ANTLER RANGE FILING NO. 1

ANTLER RANGE FILING NO. 1	POND A OUTLET STRUCTURE DETAILS (CONT.)
---------------------------	---

POND OUTLET STRUCTURE PROFILE
SCALE: 3/4"=1'

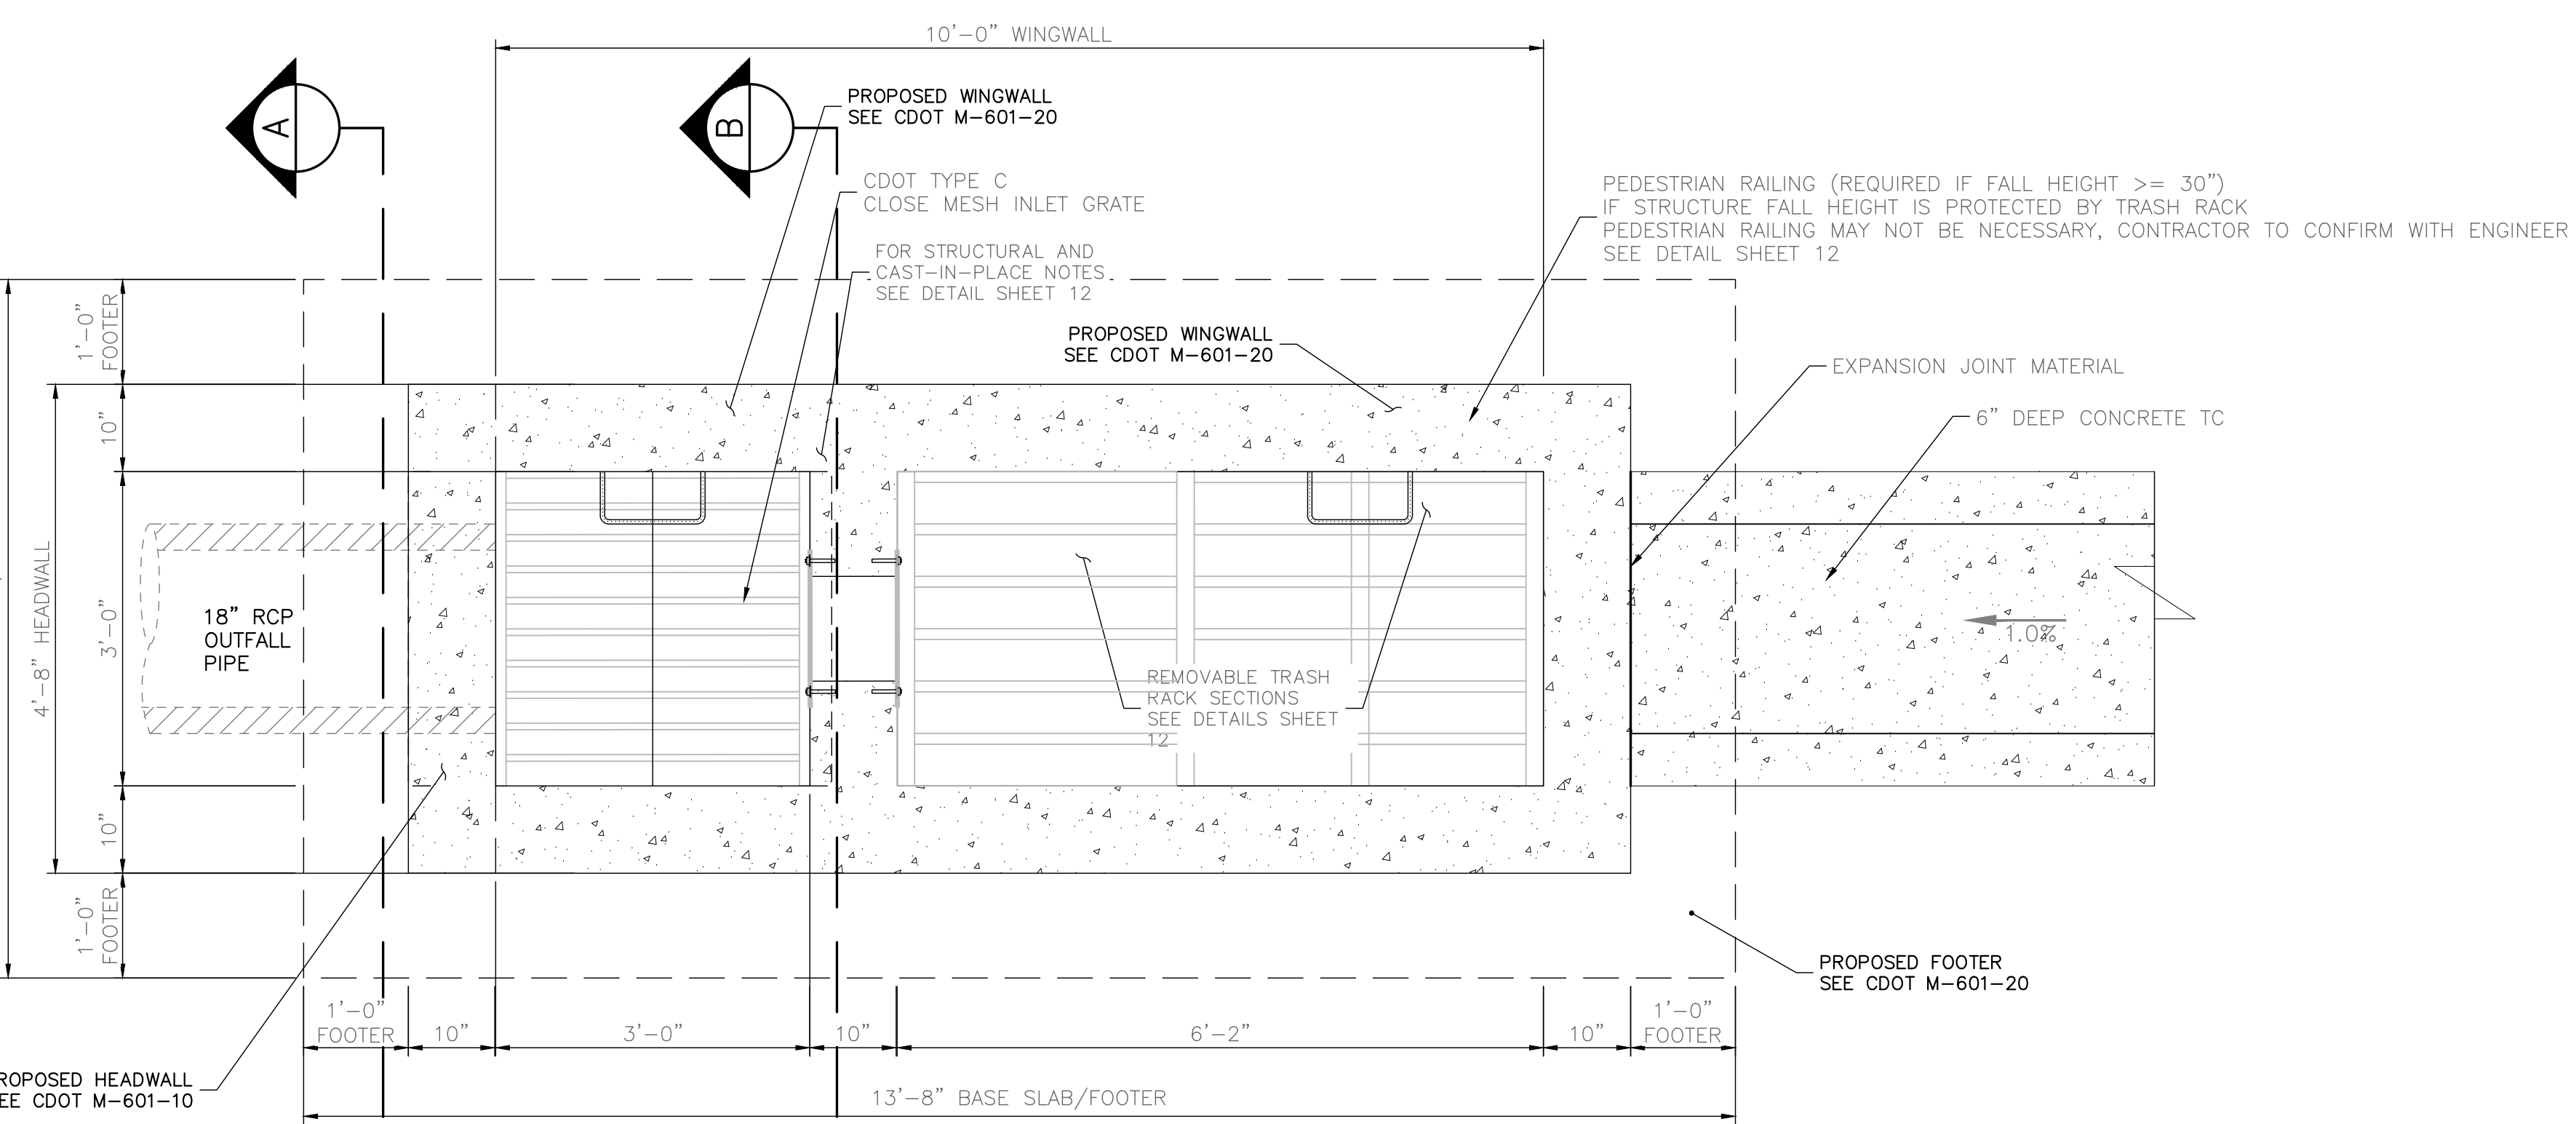
Please revise note to specify no 93 vee-wire (like call-out in trash screen detail).
